ADDENDUM NO. 5

Date: May 5, 2011
To: Shortlisted Contractors
From: Matthias Mueller - Project Manager
Reference: Residential Halls Buildings 2 and 3
Weber State University – Ogden, Utah
DFCM Project No. 10176810 and 11008810

**Addendum No. Five
for the
Weber State University
Residential Life Phase II - Buildings 2 and 3
DFCM Project Nos. 10176810 and 11008810
MHTN Project No. 2010543**

B5
SF502

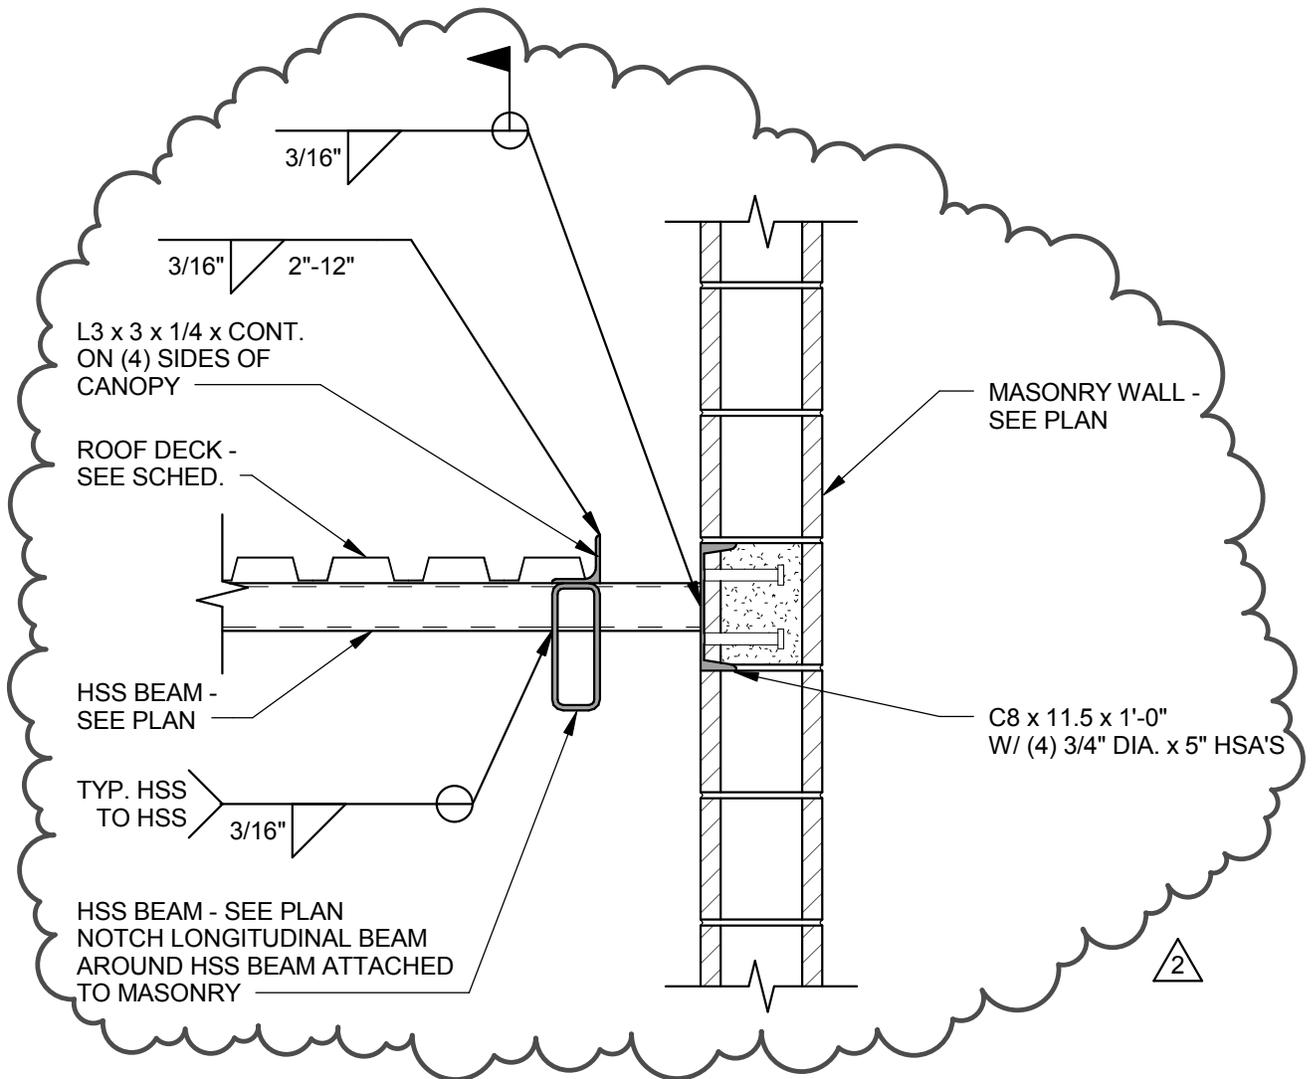
-Detail B5/SF502 has been revised. Please see the attached sheet AD05_S05.

AE509

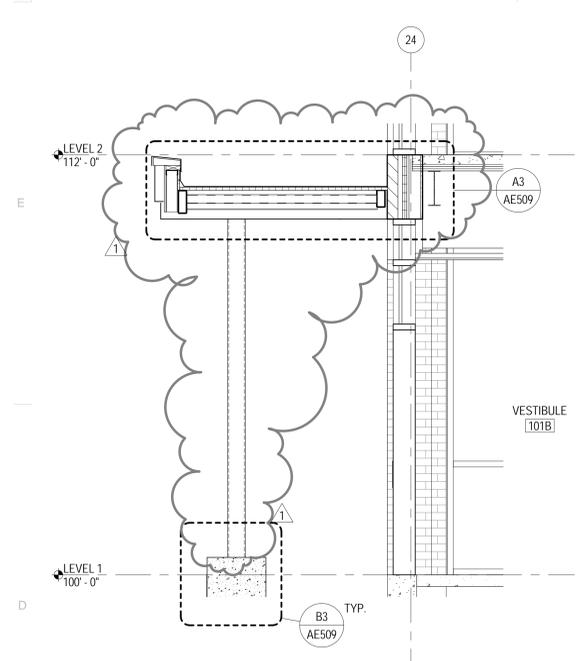
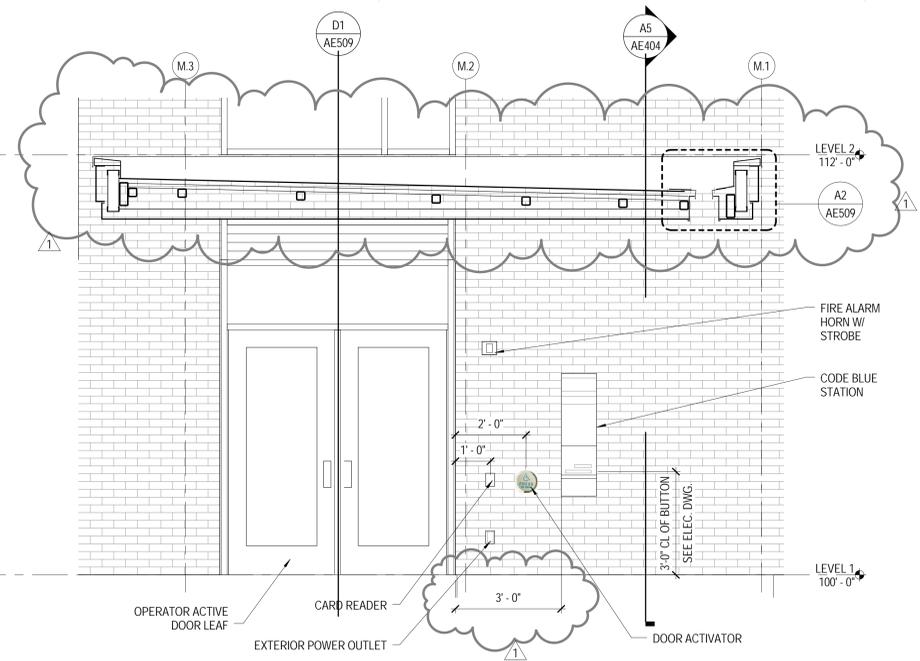
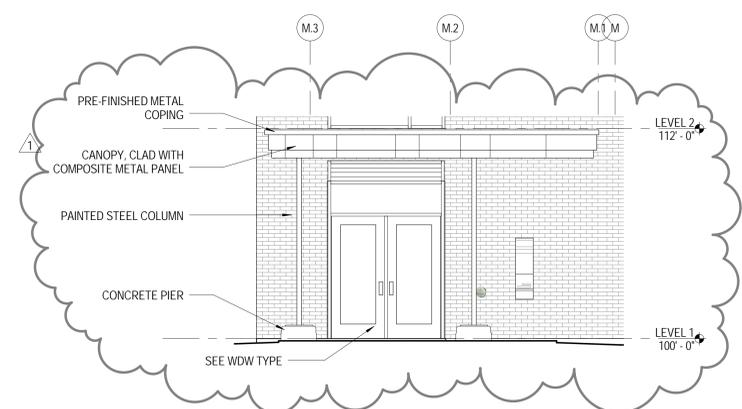
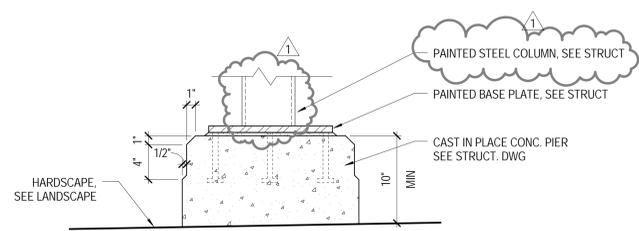
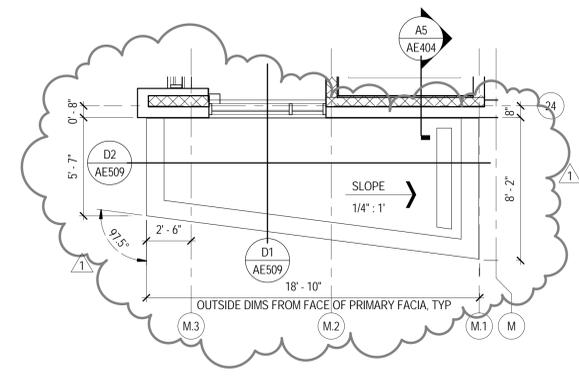
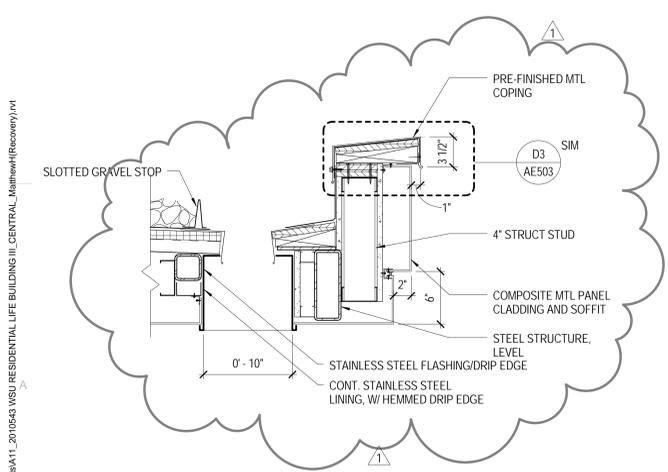
- A. Revise Canopy design as shown on Sheet AE509. Additional composite metal panel and single membrane roofing to be added to canopy.
